Addendum No. 2
October 1, 2021

Project: **Harrisburg Middle School No. 3**
Harrisburg, South Dakota
Architecture Incorporated Project #2903

Architect: Architecture Incorporated

SCD - 1

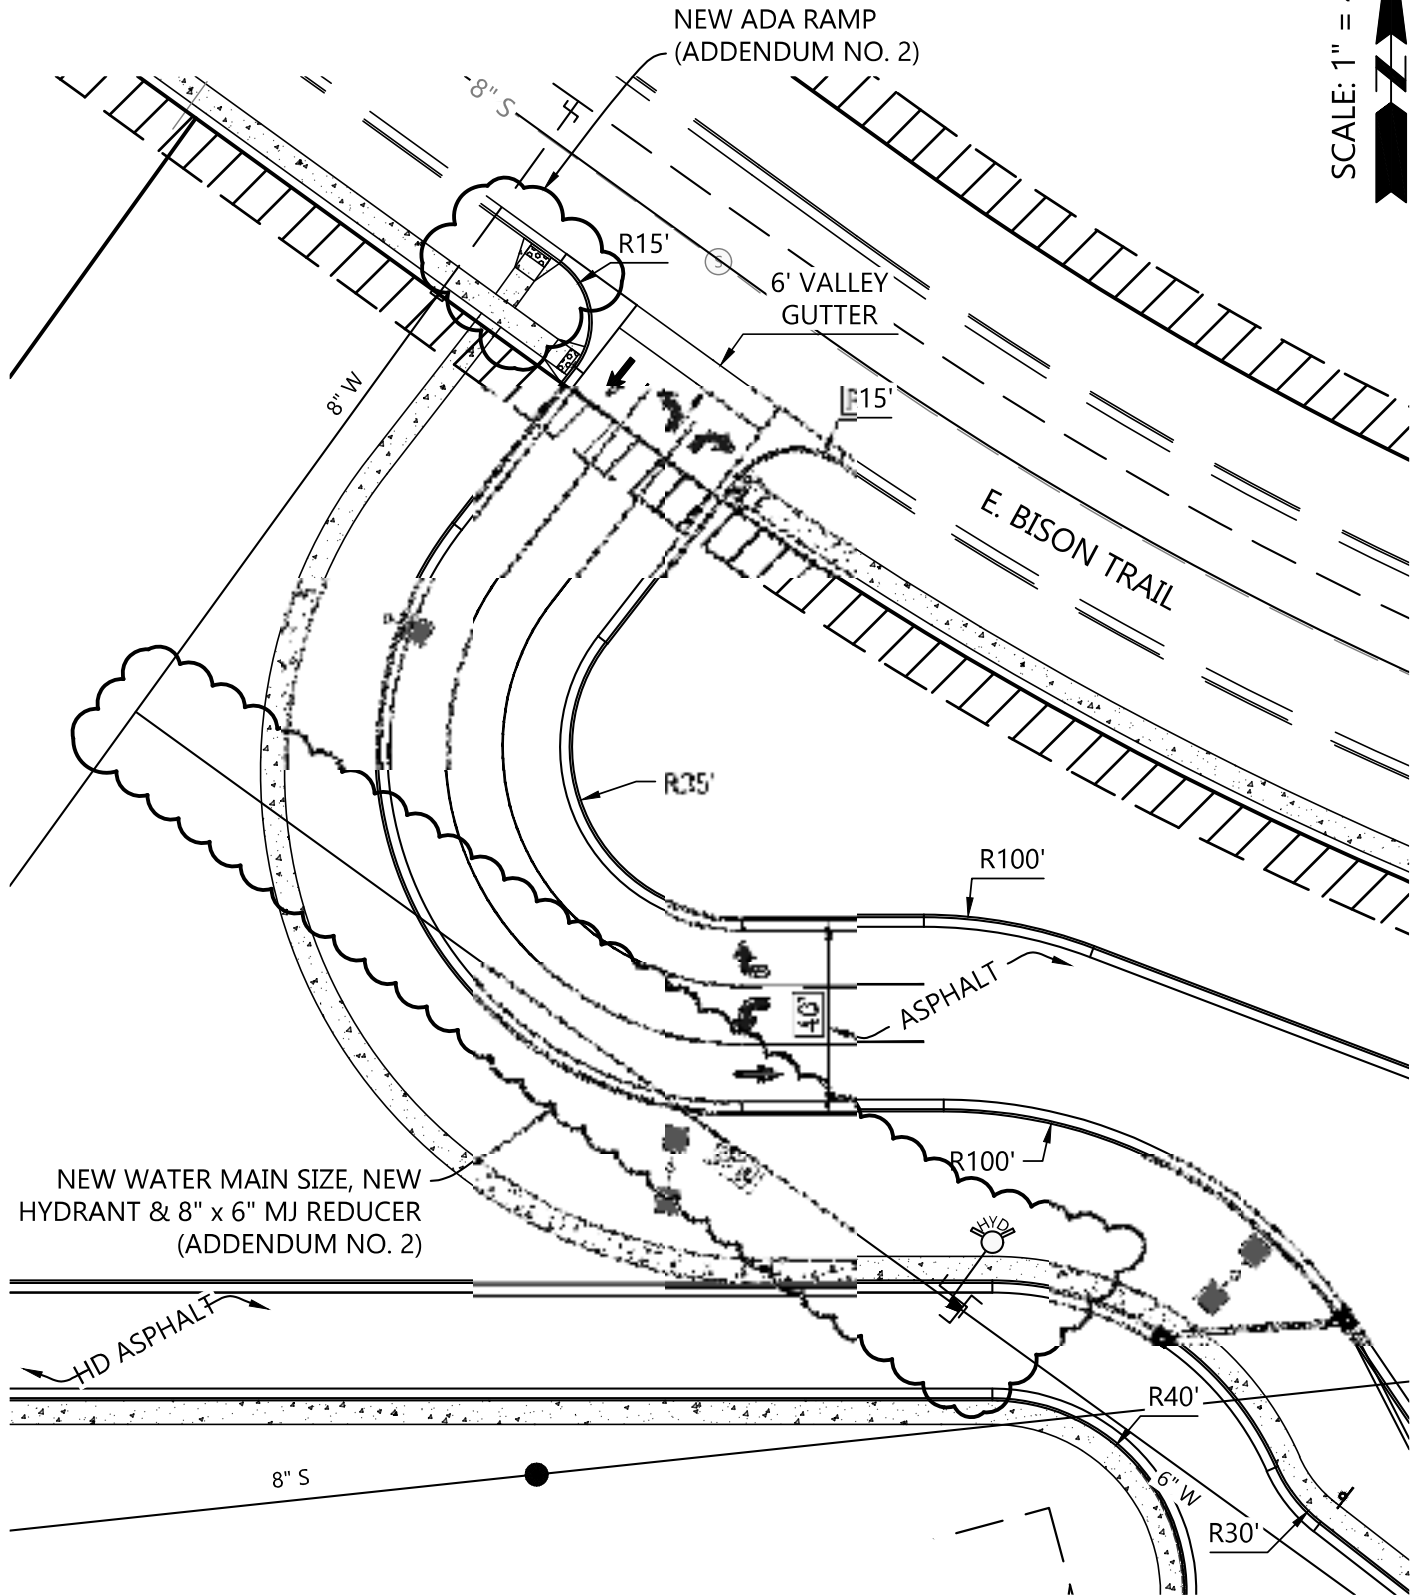
- a) Furnish and install eight (8) "No Parking Fire Lane" signs throughout the site as shown on supplemental civil drawing SCD-1, dated 10-1-21, which is attached to Addendum #2.

SCD - 2

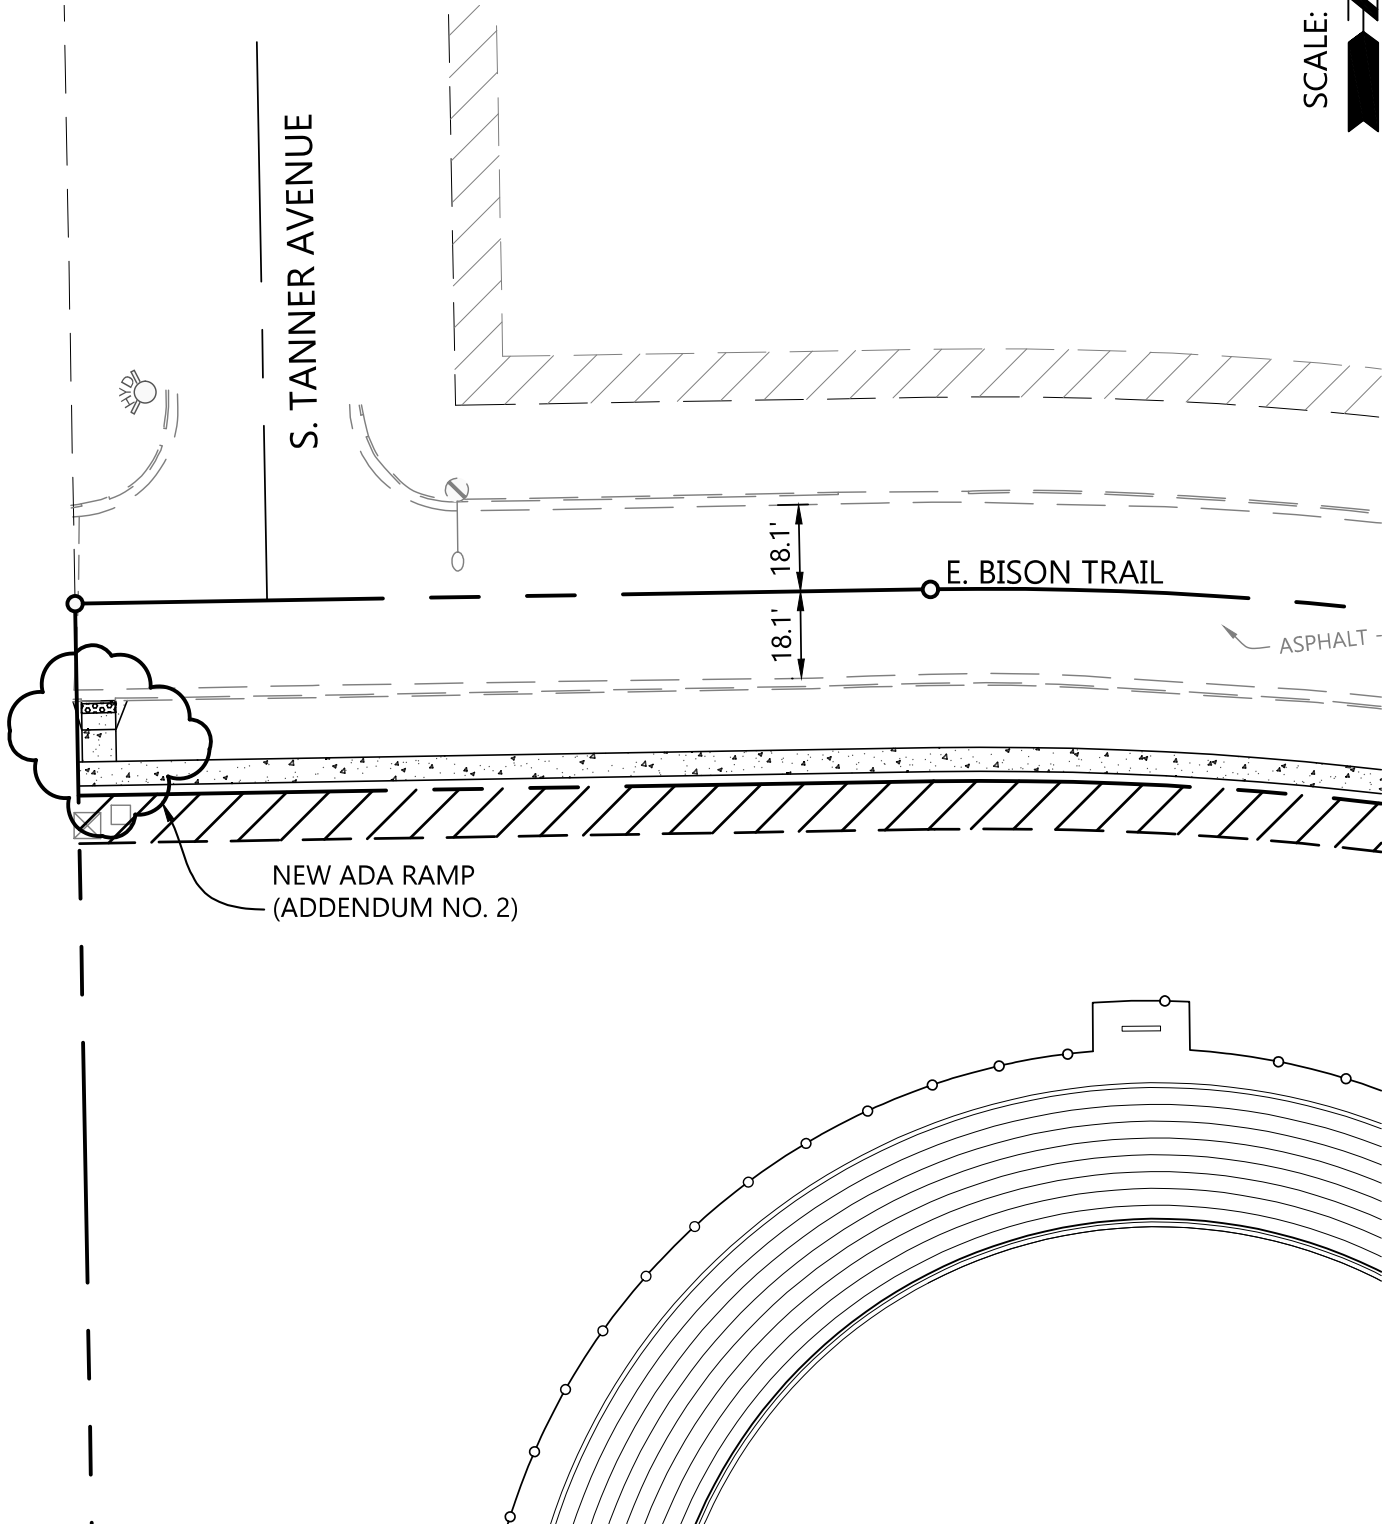
- a) Reference supplemental civil drawing SCD-2, dated 10-1-21, attached to the end of Addendum #2 for the following modifications:
 - i) W10 water main piping upsized to 8” in lieu of 6”.
 - ii) A fire hydrant and 8” x 6” MJ reducer have been added to the W10 water main layout.

SD15

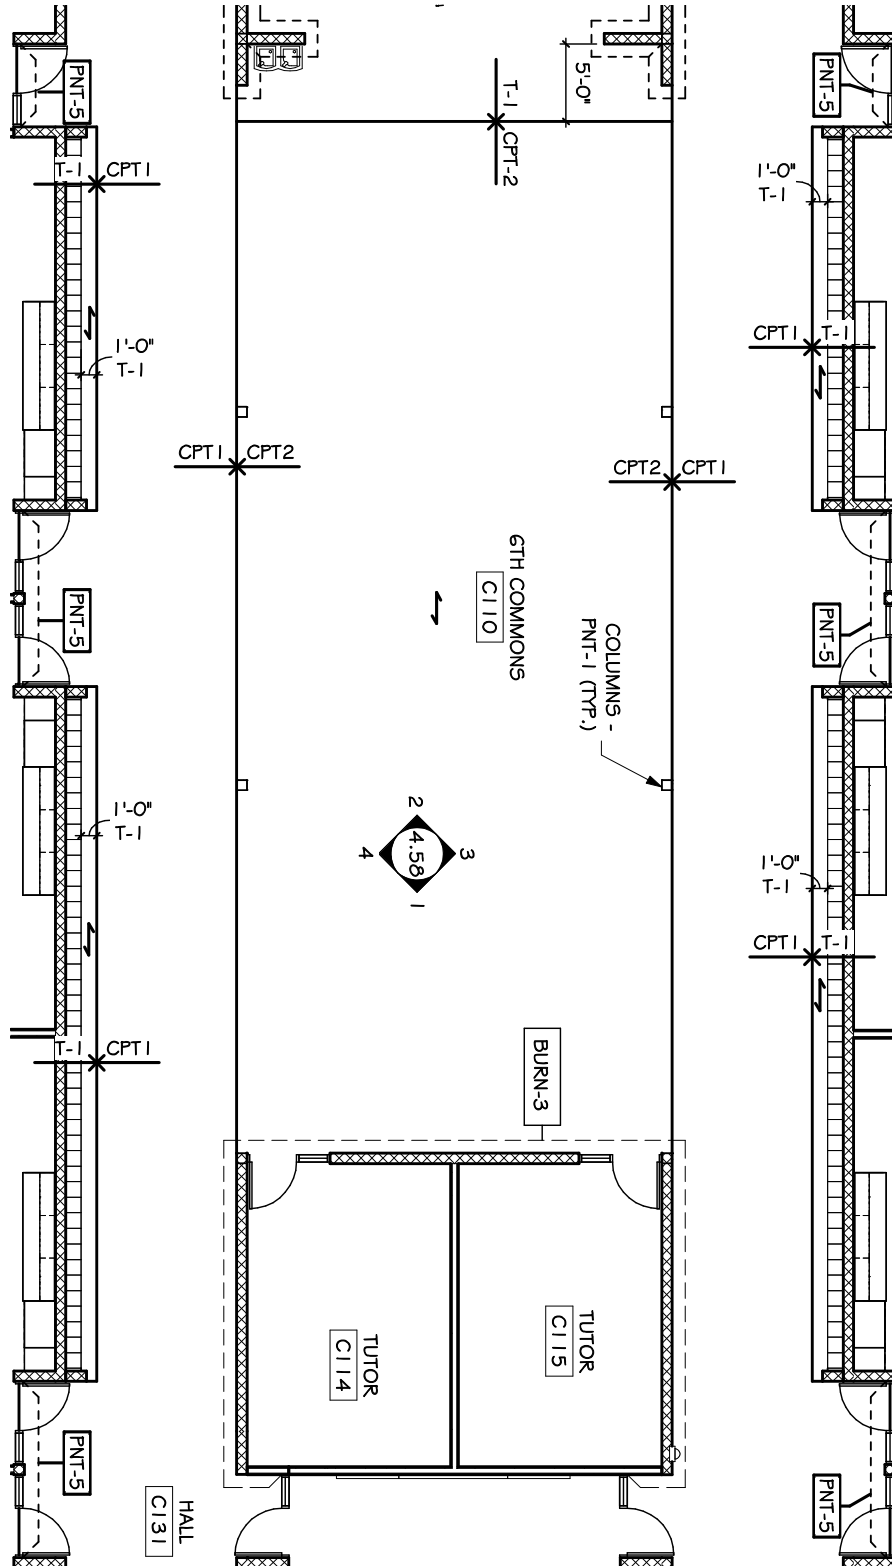
- a) Omit the gypsum board soffit originally shown in Receptionist B109.
 - i) Reference modified reflected ceiling plan on supplemental drawing SD-15, dated 10-1-21, attached to the end of Addendum #2 for additional information.

DRAWING
SD19

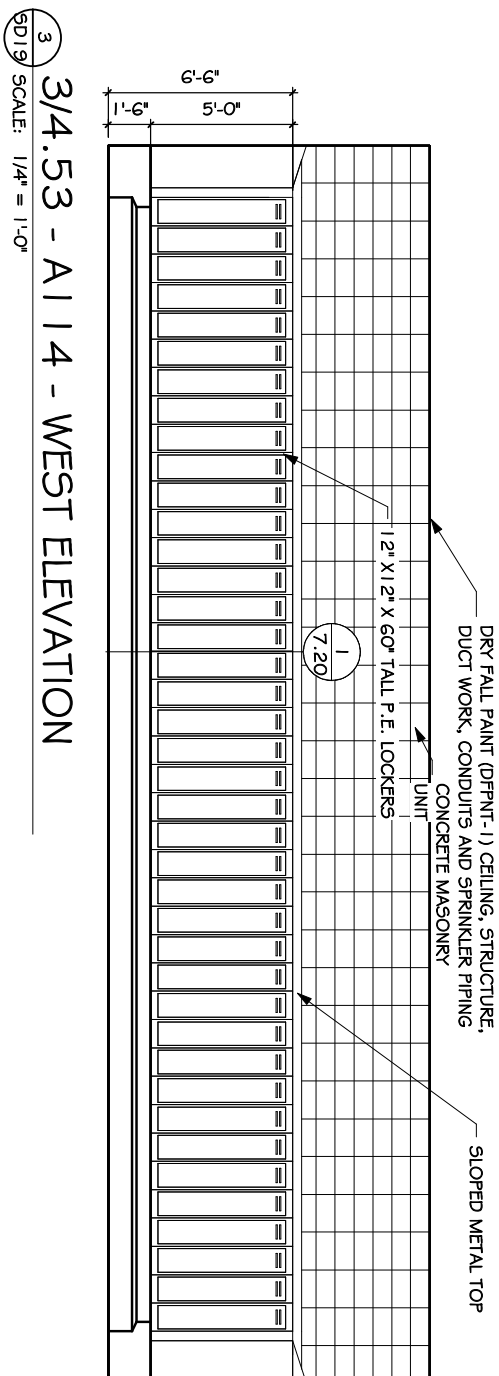
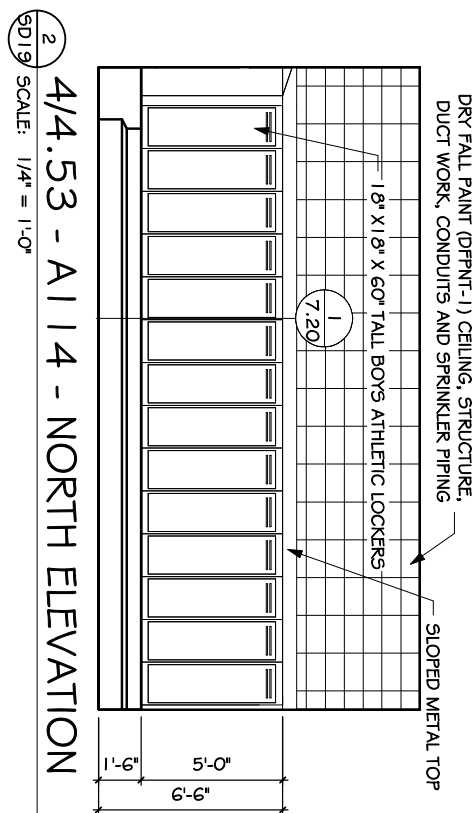
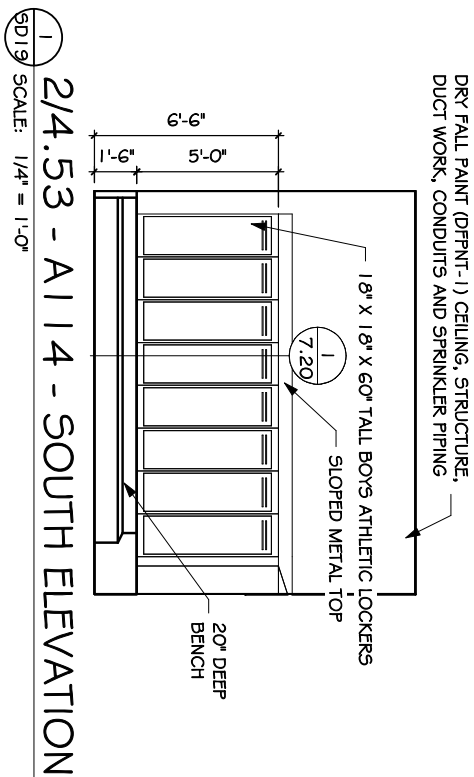
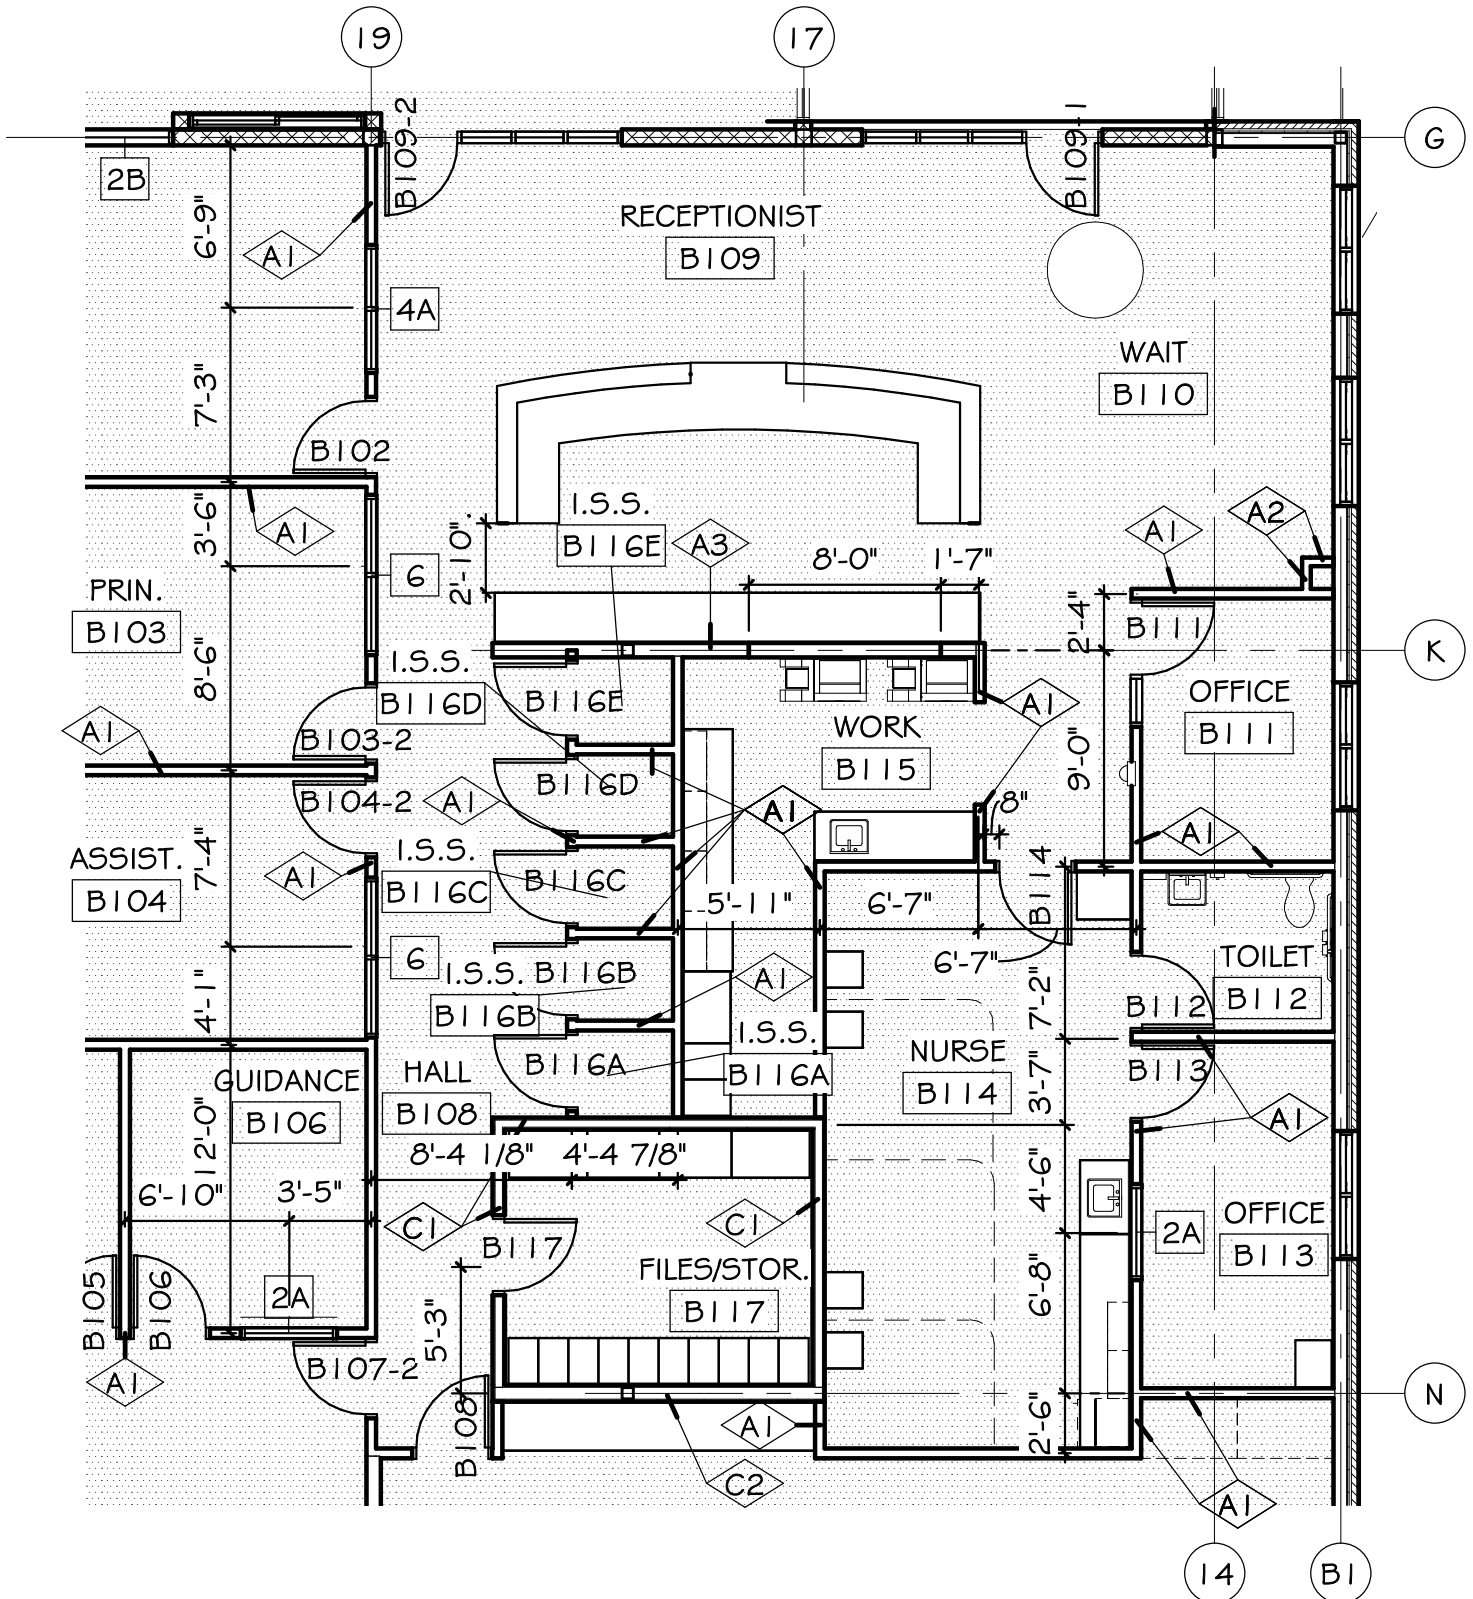
- i) Provide [**forty (40)**] 12” x 12” x 60” lockers along the west wall of Boys Locker A114; reference revised interior elevation 3 / 4.53.
 - ii) Reference supplemental drawing SD-19, dated 10-1-21, attached to the end of Addendum #2 for additional information.

- a) The Contractor shall furnish and install 18" x 18" x 60" metal athletic lockers in Boys Lockers A114 at interior elevations 2 & 4 / 4.53. Disregard all references to 12" x 12" x 60" lockers at these locations (as indicated per Addendum #1).
 - i) Provide forty (40) 12" x 12" x 60" lockers along the west wall of Boys Locker A114; see revised interior elevation 3 / 4.53.
 - ii) Reference supplemental architectural drawing SD-19, dated 10-1-21, attached to the end of Addendum #2 for additional information.
